Docket Item # 6
BAR CASE #2006-0118

BAR Meeting
June 28, 2006

ISSUE: Addition and alterations
APPLICANT: Donald Walsh by John Savage
LOCATION: 323 Buchanan Street
ZONE: RB/Residential

Figure 1 Proposed side elevation

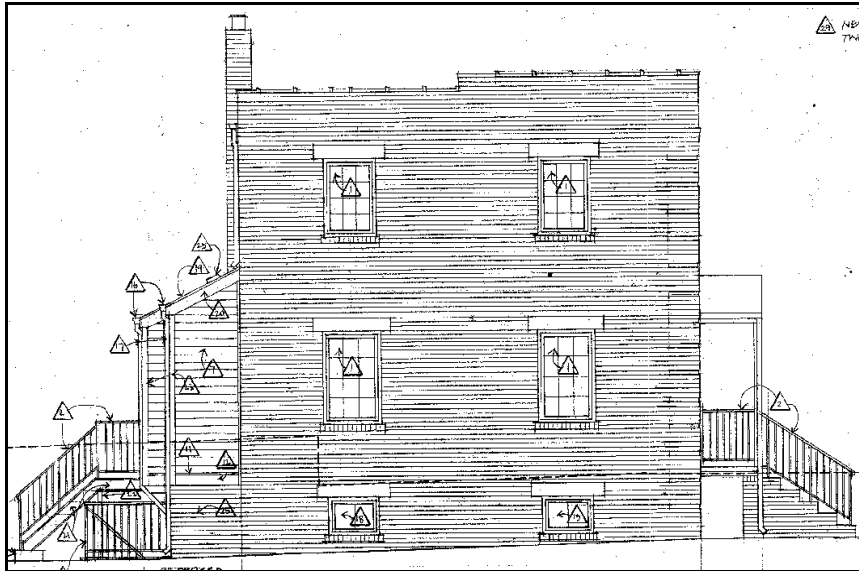
Staff believes the proposed use of fiber cement on the addition is appropriate with the condition that the nails not show in the installation and that smooth siding be installed.

Figure 2 Proposed rear elevation

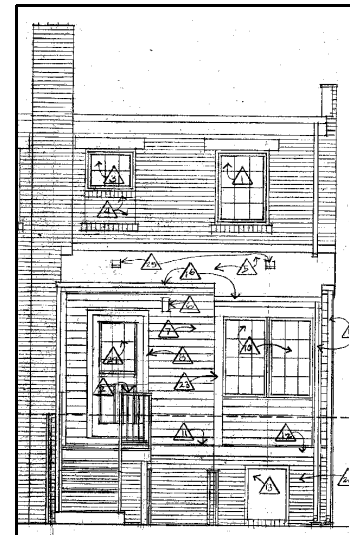
Staff objects to the proposed reduction in size of the window on the left side of the second story in the rear. The architect has explained that the reason for requested alteration is that this window is over a tub and the homeowner is seeking improved privacy. However, staff notes that none of the other windows in the row, which presumably are similarly located, have been altered. With only six windows on the second floor, it would seem desirable to retain as much window area as possible to optimize natural light and ventilation. Staff recommends that a less permanent solution be utilized to increase privacy and that the full window size be maintained.

Proposed plans seem appropriate, except for reduction of the second-story window on the rear facade which would alter the second-story fenestration of the entire row-house complex. It

would be preferable to retain the original size window.

1. That the windows have simulated divided lights with fixed exterior muntins and an internal spacer bar and that the window selection be approved by Staff before installation;
2. That the left side window opening in the second floor at the rear not be reduced in size; and,
3. That the fiber cement siding be smooth and that the nails not show in the installation.
